SJ PARTS SALES BULLETIN 2024

SJ08/SJ10Aのフリクションクラッチ形状変更
SJ08 and SJ10A Series friction clutch shape change

SJ-G/Hシリーズ 新定期整備キットのお知らせ New Overhaul kit for SJ-G/H series

SJ10A 下部軸受ハウジング用座金を部品リストに追加 SJ10A Added washer for lower bearing housing to parts list

O-ring kits for biofuel on sale

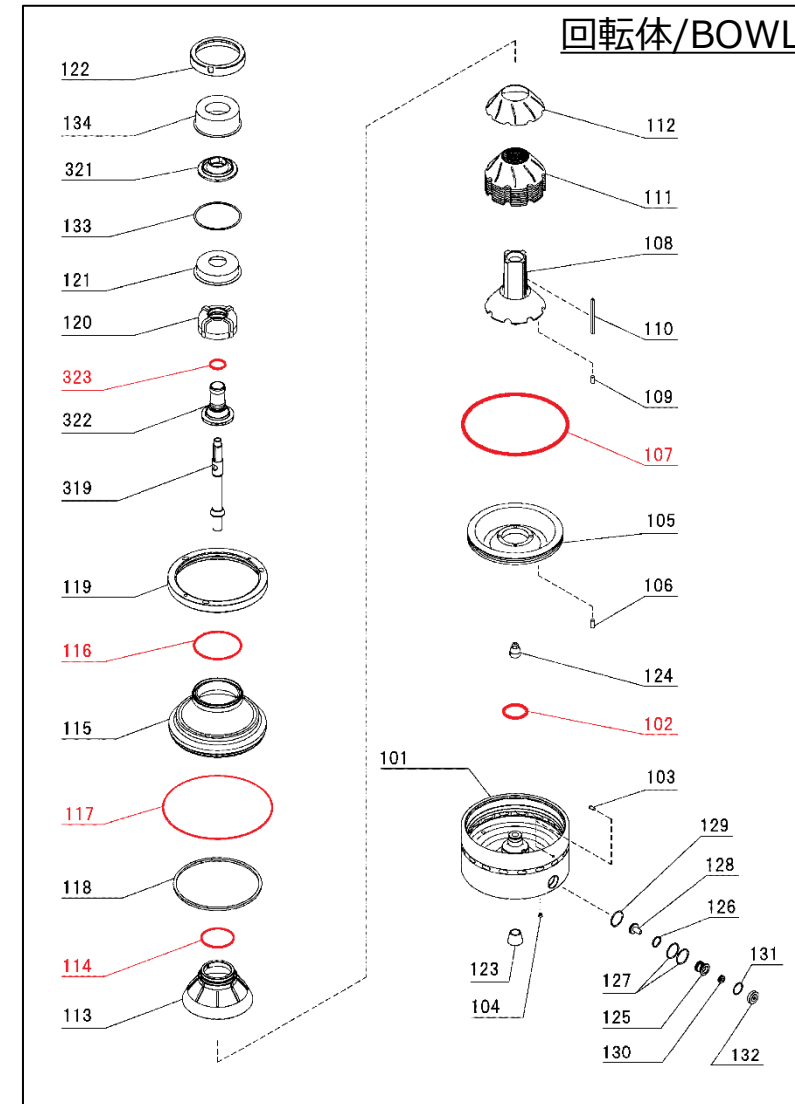
バイオ燃料の使用を検討されているお客様からのお問い合わせが増えてきたことから、接油部のOリングをバイオ燃料の性状に対応した材質に変更したOリングキットを販売致します。

As the number of vessels using biofuel has been increasing, we've started selling O-ring kit compatible with biofuel which swells the normal O-rings in the short term.

Kit No.

SJ-H Series	Kit No.	SJ-G Series	Kit No.
SJ15H/HH	BF015H	SJ10G/GH	BF010G
SJ25H/HH	BF025H	SJ20G/GH	BF020G
SJ35H/HH	BF035H	SJ30G/GH	BF030G
SJ60H/HH	BF060H	SJ50G/GH	BF050G
SJ85H/HH	BF085H	SJ60G/GH	BF060G
SJ110H/HH	BF110H	SJ70G/GH	BF070G
SJ160H/HH	BF160H	SJ100G/GH	BF100G
SJ220H/HH	BF220H	SJ120G/GH	BF120G
—	—	SJ150G/GH	BF150G

Symbol No. of O-rings in kit

Symbol No.	
102	311
107	315
114	318
116	323
117	333
220	
227	
303	
310
